Re: Inspection Reports for Wastewater Treatment Facilities Operated by the Northern Cheyenne Utilities Commission

NPDES Inspection Report – POTW

Facility Location Information	
Site/Facility Name & Location: Lame Deer Wastewater Treatment Facility 45.628889, -106.673611 Lame Deer, Montana	Mail Report to: Sheri Bement, General Manager Northern Cheyenne Utilities Commission P.O. Box 747 Lame Deer, Montana 59043

Photo number 173 taken by Emilio Llamozas on 6/13/2018.

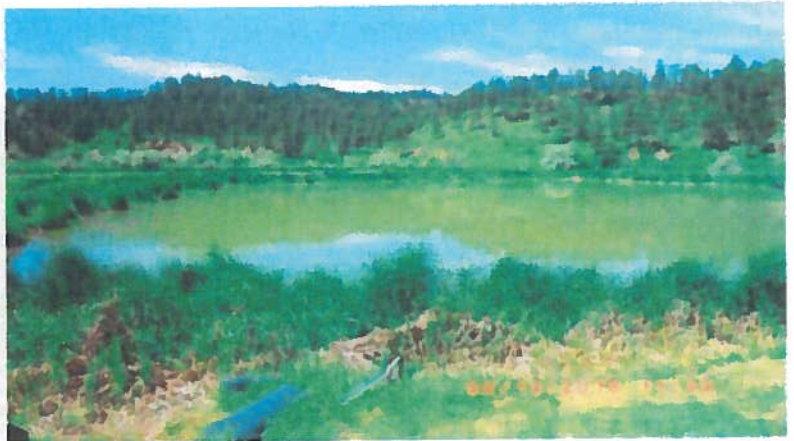
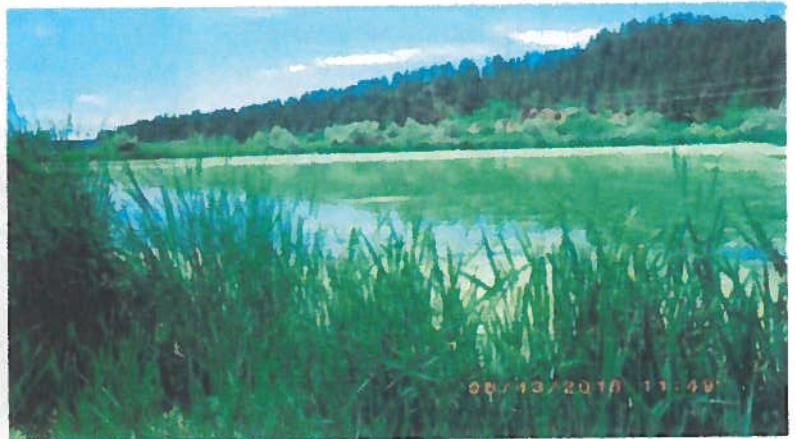
During the inspection, Adamas Construction was preparing Cell 2 for sludge removal. Floating aerators had been removed from the cell (Photograph 173) and floating bunches of cattails were being pulled towards the shorelines (Photograph 170). To inspect berm integrity, we walked the southeastern berm along Cell 1 to the fermentation pits (Photographs 168 and 172). The berms around Cell 1 and the fermentation pits had recently been mowed. In the southern corner of Cell 1, historical septic dumping had eroded a portion of the berm (Photograph 168), potentially impacting berm integrity. Facility representatives indicated the practice of emptying septic trucks directly onto the berm had been discontinued.

We then proceeded along the berm between Cell 1 and Cell 2 (Photograph 173). We continued along the northwestern berm of Cell 3 (Photograph 174) to the effluent sampling point (Photograph 175) and discharge point, Outfall 001 (Photograph 176). Effluent leaving Cell 3 appeared light green in color (Photograph 175). Tall vegetation was present on the berms around Cell 2 and Cell 3 and the path to the outfall into Lame Deer Creek from Cell 3 was obscured (Photograph 176). It is noted there was no mechanism employed to determine flow rates of effluent discharging from the lagoon. Additionally, Mr. Pierce stated all gate valves at transfer stations between cells were broken, meaning there was no way to control or retain flow within the lagoon system.

Overview of Cell 2. Note the color was a brown green opaque color. Floating aerators (foreground) had been removed from the cell in preparation for the upcoming sludge removal and Bio-Dome installation.

Photo number 177 taken by Emilio Llamozas on 6/13/2018.

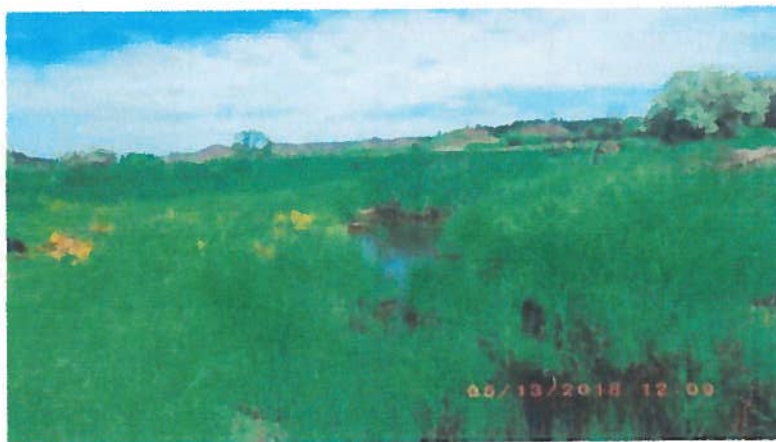
Finding 5:

A manhole associated with unknown subsurface infrastructure along the northeastern berm of Cell 3, downgradient of the influent lift station was identified during the inspection (45.627961, -106.673186) (Photograph 177). It was unknown if any water flowed through the manhole and, if it did, where it flowed from or to.

We were not able to remove the manhole cover during the inspection. It is possible the manhole could be directing sewage or stormwater directly into Cell 3, bypassing a portion of the treatment system.

A manhole associated with unknown subsurface infrastructure along the northeastern berm of Cell 3, downgradient of the influent lift station (45.627961, -106.673186). We were not able to remove the manhole cover during the inspection. It was unknown if any water flowed through the manhole and, if it did, where it flowed from or to.

Corrective Action 5:

Ensure the manhole identified along the northeastern berm of Cell 3 is not conveying water directly into Cell 3. In a response to EPA, provide a photograph and written narrative indicating this corrective action has been completed and indicate the date this corrective action was completed.
